**Agenda**  
**City of Springboro Planning Commission Meeting**  
**Wednesday, November 10, 2021, 6:00 p.m.**  
**Council Chambers, Springboro City Building, 320 West Central Avenue**

**A. Final Approval**

Final Development Plan, Advanced Drive PUD, Planned Unit Development, commercial building

# ADVANCE DR. SPEC. #3

#### LANDSCAPE PLAN

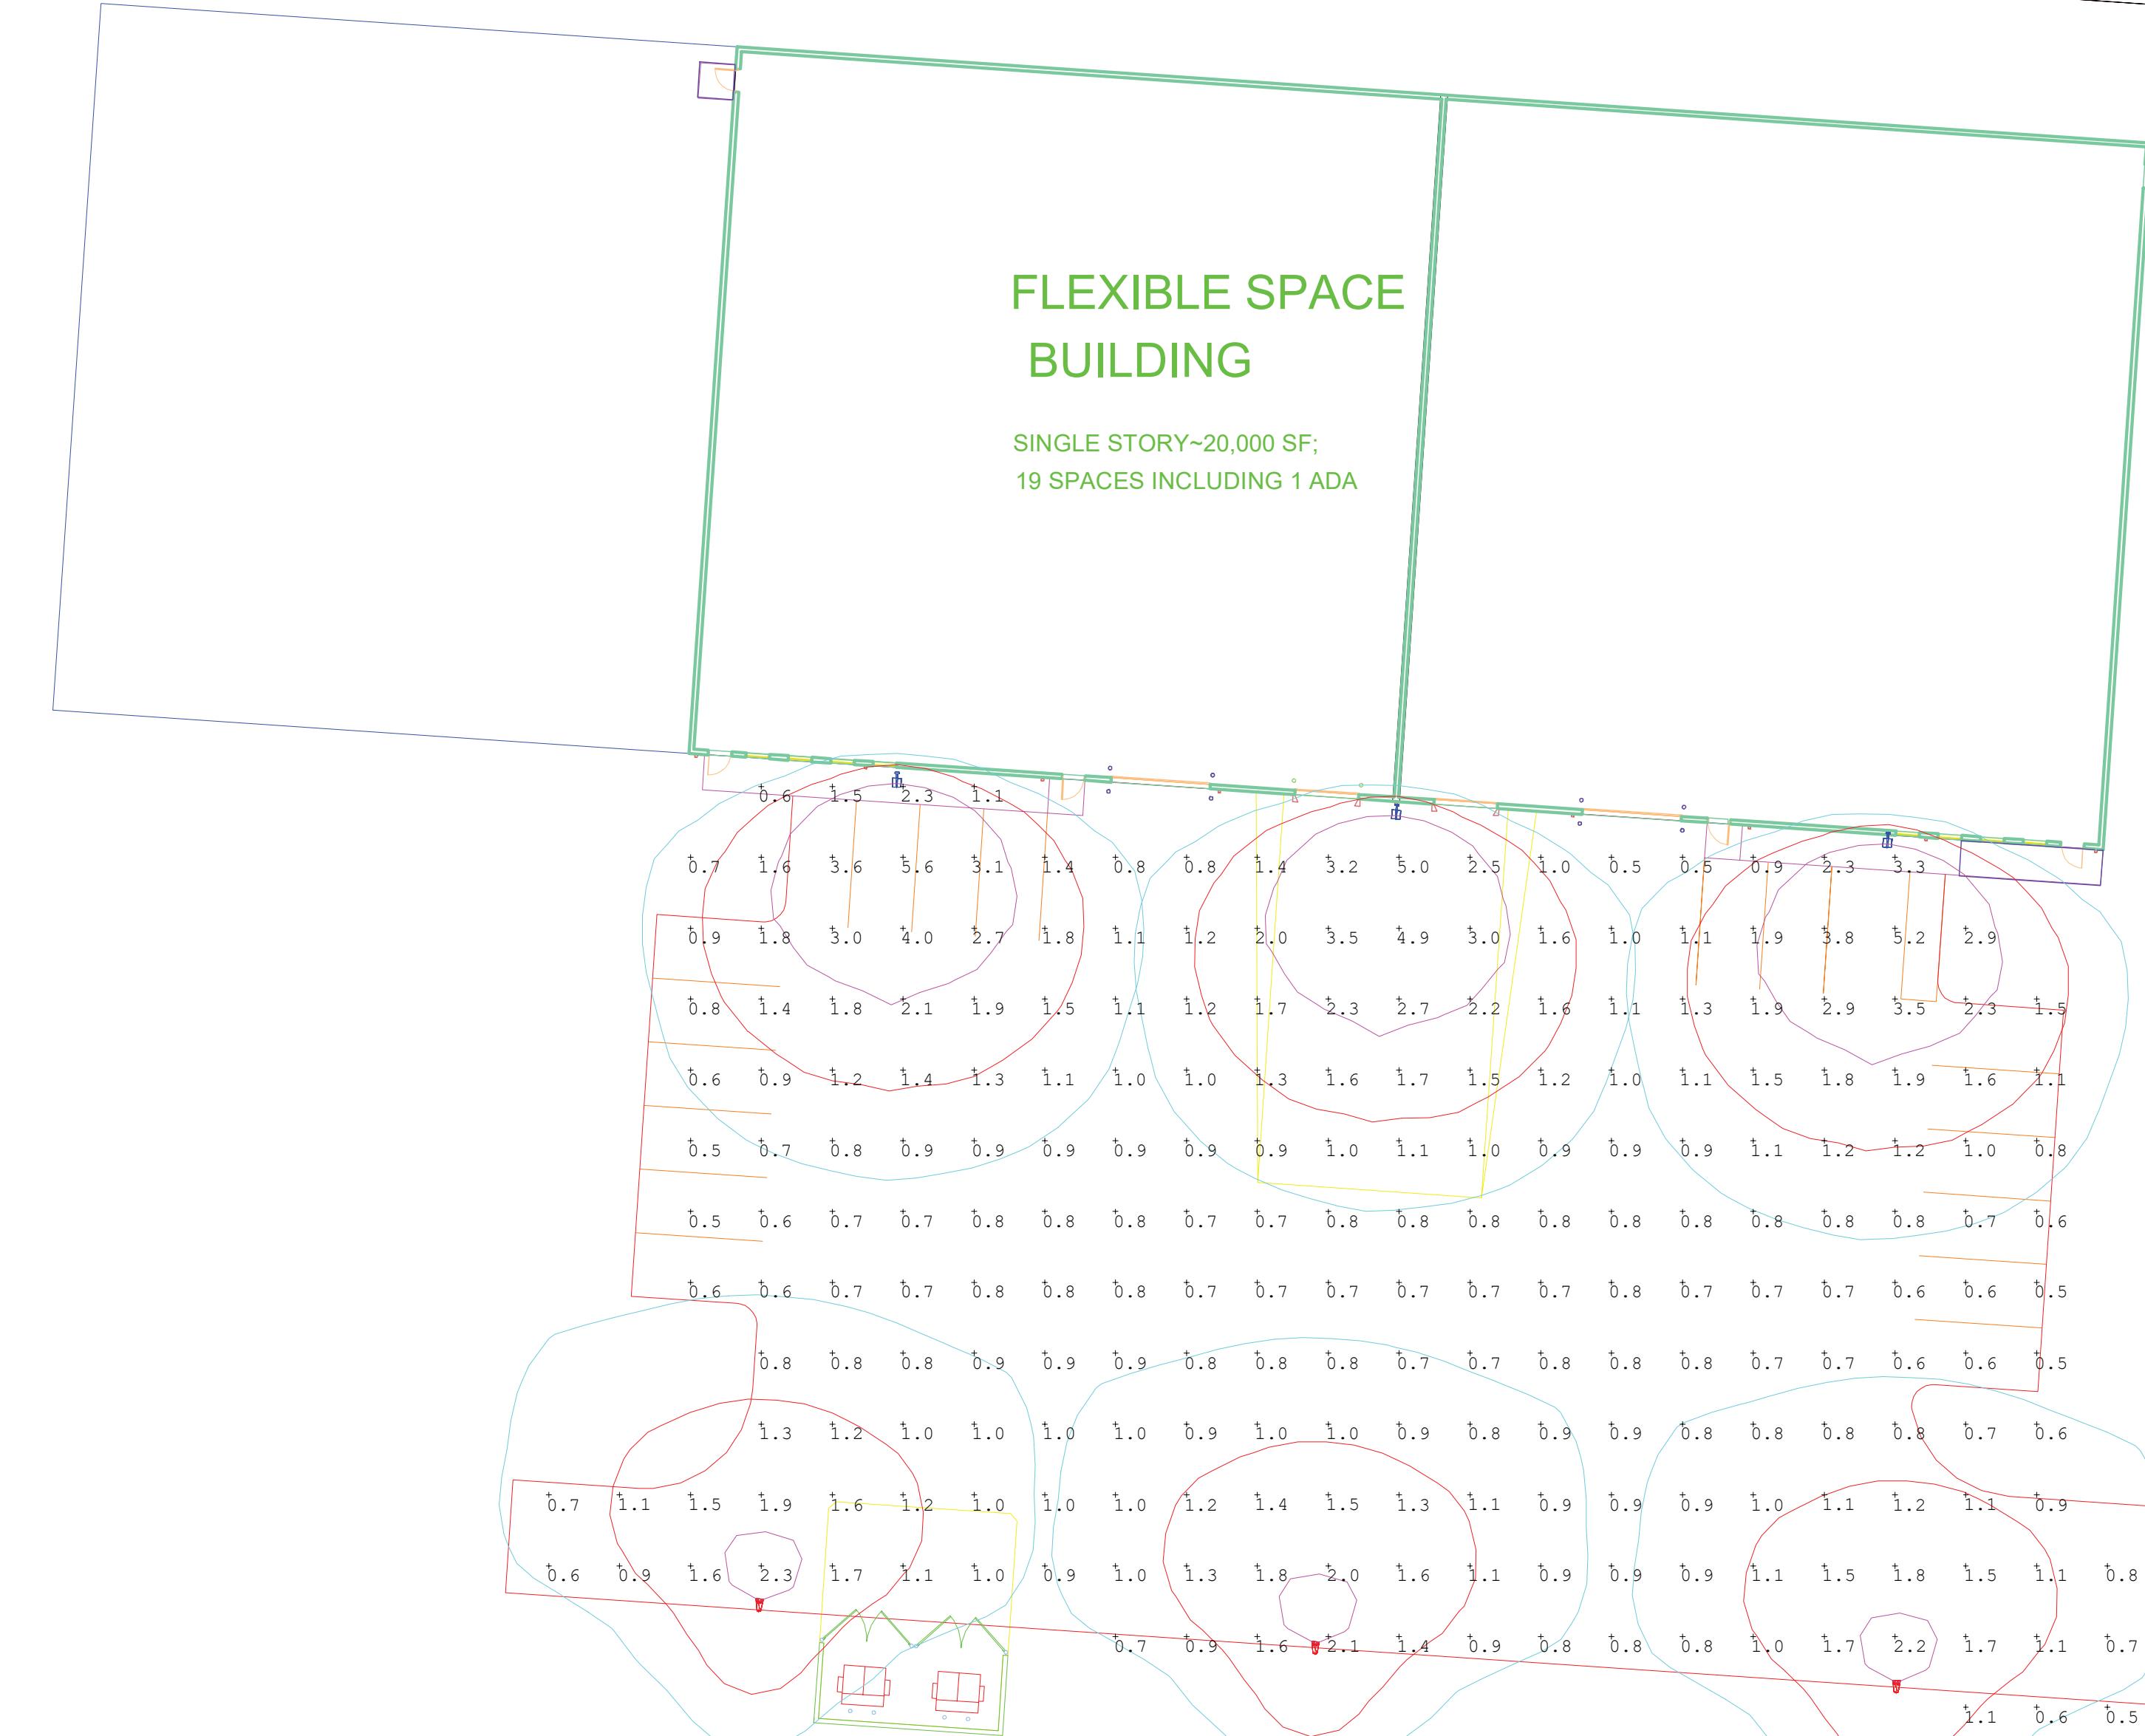
2. Revise landscaping plan to address the following:
  - a. Indicate all existing vegetation 4 inches DBH or larger to remain on site for credit against requirements of Chapter of the Planning and Zoning Code. This may reduce the number of plantings required as described below.

- b. For landscaped buffer required on north, provide 3 additional trees (9 provided, 12 required); for landscape buffer to south provide 4 additional trees (8 provided, 12 required).

- c. Indicate long-range plans for the west end of the property in light of buffering requirements and credit that may be provided by existing vegetation.

- d. Provide 38 trees for site coverage requirement based on estimated 2.64-acre site. See also (a) above.
3. Revise lighting plan to address photometric analysis which exceeds 10:1 maximum to minimum ratio. Average to minimum ration is now compliant as is revised photometric analysis complies with City standards.

**DUMPSTER ENCLOSURE PLAN**

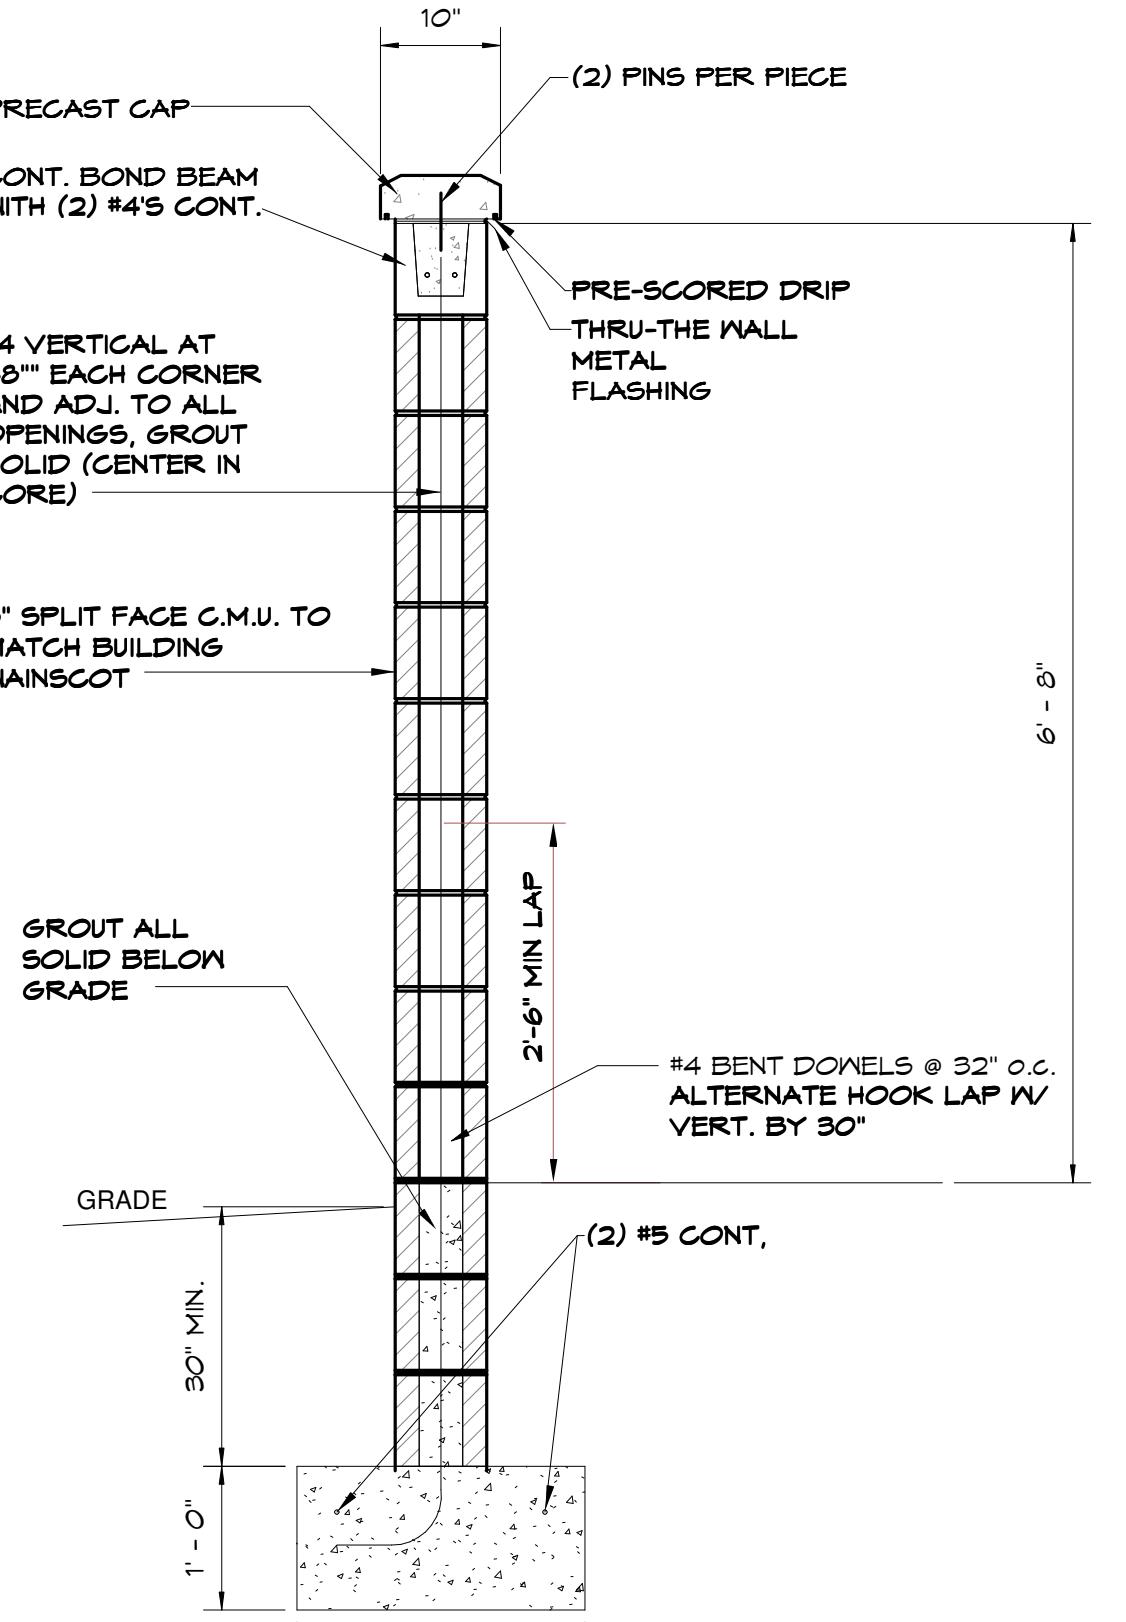
4. Construction requirements within the existing pipeline easement area to be worked out with pipeline companies.
5. Adjust dumpster location or proposed property line to south to provide 15-foot separation from property line.
